TOWN OF EAGLE

REFERRAL RESPONSE SUMMARY REPORT (RRSR)

1ST REVIEW

Project Name: Haymeadow Neighborhood A1 Preliminary Plan Update and Filing 2 Final Plat

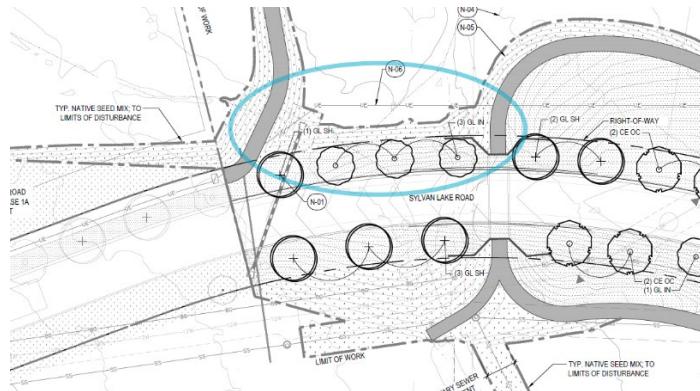
14. Provide pedestrian and trails plan specific for A1 – show what has been completed as part of Filing 1 and what will be completed as part of Filing 2. This plan could also show where future connections will be made or rough estimates of future connections.

Response: An updated pedestrian and trails plan is provided with the resubmittal materials showing all requested information. As shown on the proposed Phasing Plan, the proposed phasing of the road and trail improvements is as follows:

- Phase 1 – Sylvan Lake Road Extension area
- Phase 2 – Neighborhood A1 Completion area
- Phase 3 – Sylvan Lake Road to Ouzel Lane area

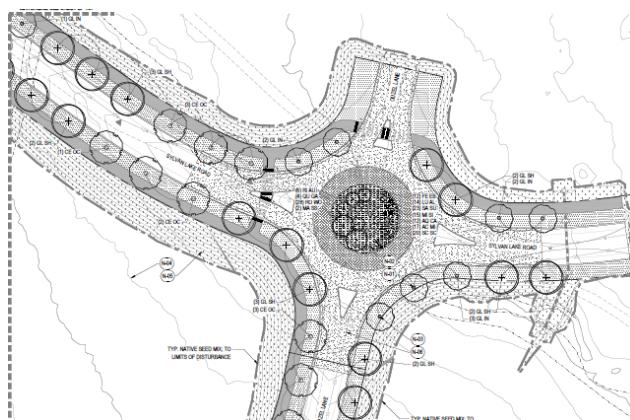
16. Is there meant to be a trail connection here:

Response: Yes, the updated pedestrian and trails plan shows a primary path connection along the entire north side of Sylvan Lake Road, including this location.

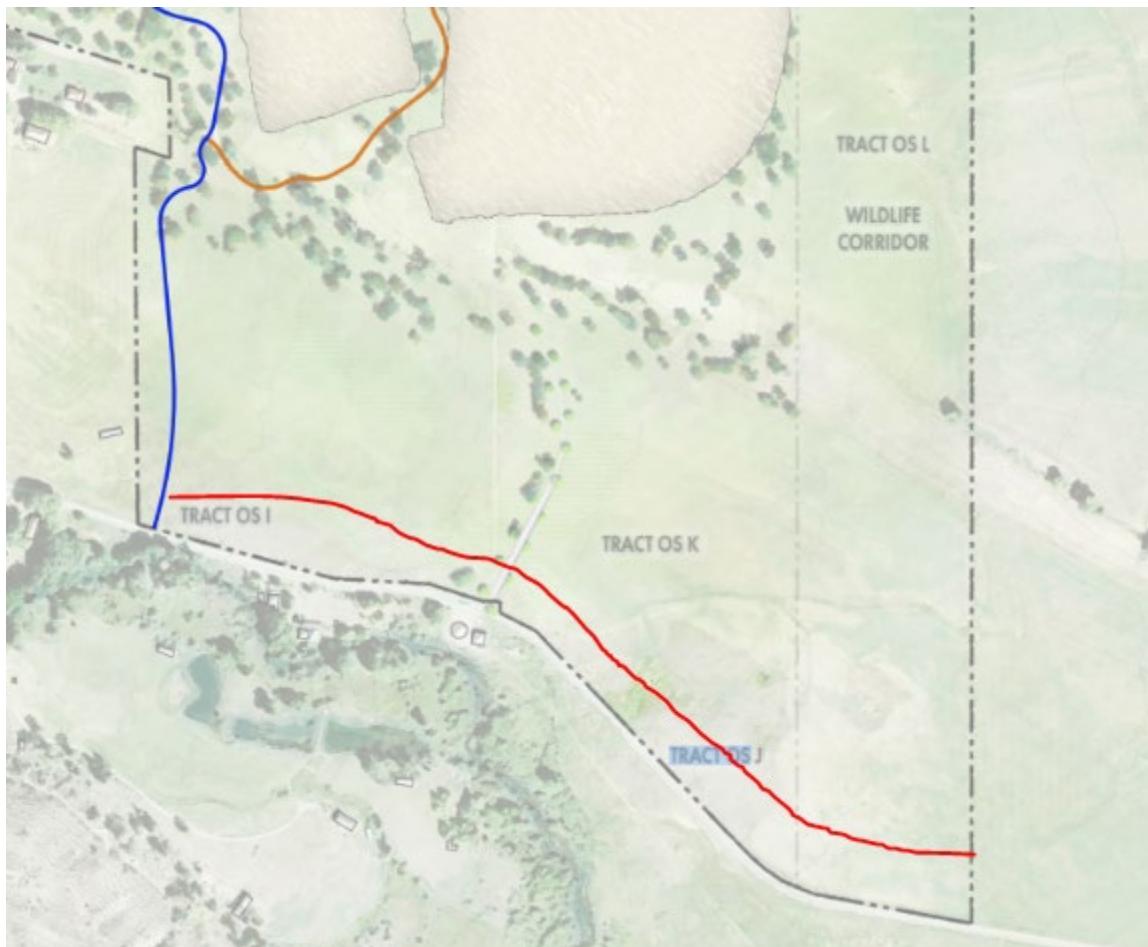
2. The plan for the adjacent Brush Creek Valley Ranch and Open Space contemplates access via a paved community trail paralleling Brush Creek Rd. that could connect to the Haymeadow property. Eagle County OSNR strongly encourages the town and applicant to take a holistic view of the Brush Creek Rd. corridor and contemplate existing and future community wide connections through the proposed development. Furthering the primary path (suggested route in red) from OS tract I through OS tracts J, K, and L would complement existing and planned trail connections. Including this trail option would allow for Haymeadow residents trail access to the West Eagle SRMA, Brush Creek Valley Ranch and Open Space trail systems, and public lands access points further south along Brush Creek Rd.

Response: While this application is specific to platting the rest of Neighborhood A1 and the blue line is the limit of the applicant's commitment in the approved Haymeadow PUD Trails Plan, Abrika/Haymeadow dedicated 30-ft of land along Brush Creek Rd to the Town to facilitate the ability for the Town and/or County to provide this suggested trail connection.
